Access Compliance Report

Public Rights-of-Way

Intersection ID: 53775	Main Street: STRAWBERRY_FIELDS_LN	Cross Street: CHAPECLANE_RD	Location: SE
ADA ID: 08A9EDBB09C3	Ramp Type: BlendTrans1	Initial Pass/Fail: Fail	Overall Compliance: No
		Severity Score: 1.25

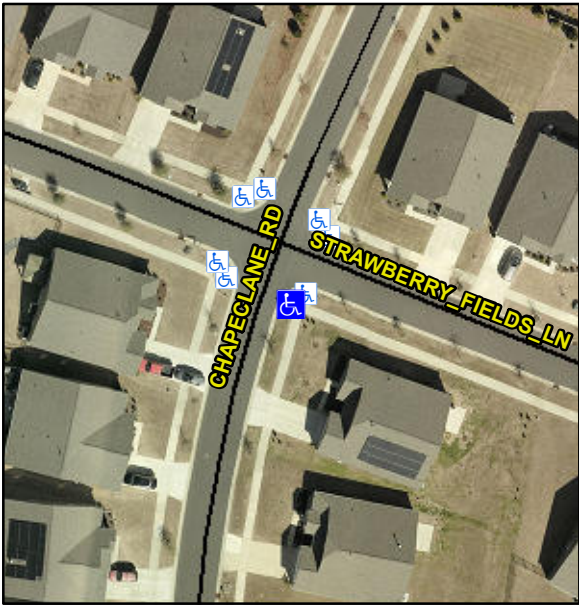
Codes/Mitigation Info/Possible Solution			Field Measurements/Component Compliance					
	Possible Solutions:		Compliance	Description	Data	Compliance	Description	Data
	Remove & Replace Curb Ramp With Two New Directional Ramps or Equivalent.		N/A	Ramp Length (in)	83.0	Yes	BlendTrans Slope (%)	3.8
			Yes	Ramp Width (in)	48.0	No	BlendTrans XSlope (%)	3.1
			N/A	Flare Type LT	N/A	N/A	Flare Type RT	N/A
			N/A	Flare Slope LT (%)	N/A	N/A	Flare Slope RT (%)	N/A
			N/A	Flare Traversable LT?	N/A	N/A	Flare Traversable RT?	N/A
			N/A	Landing Length (in)	N/A	N/A	DWS Provided?	N/A
			N/A	Landing Width (in)	N/A	N/A	DWS Contrast?	N/A
			N/A	Landing Slope (%)	N/A	N/A	DWS Length (in)	N/A
			N/A	Landing X Slope (%)	N/A	N/A	DWS Full Width?	N/A
Surveyor Notes: N/A PROW/ADA: R304.5.3			N/A	Landing Curb? (Y/N)	N/A	N/A	DWS Offset (in)	N/A
			N/A	Shared Landing?	N/A			
			N/A	Gutter Ponding?	N/A	N/A	Gutter Slope (%)	N/A
			N/A	Gutter Lip Ht (in)	N/A	N/A	Gutter X Slope (%)	N/A
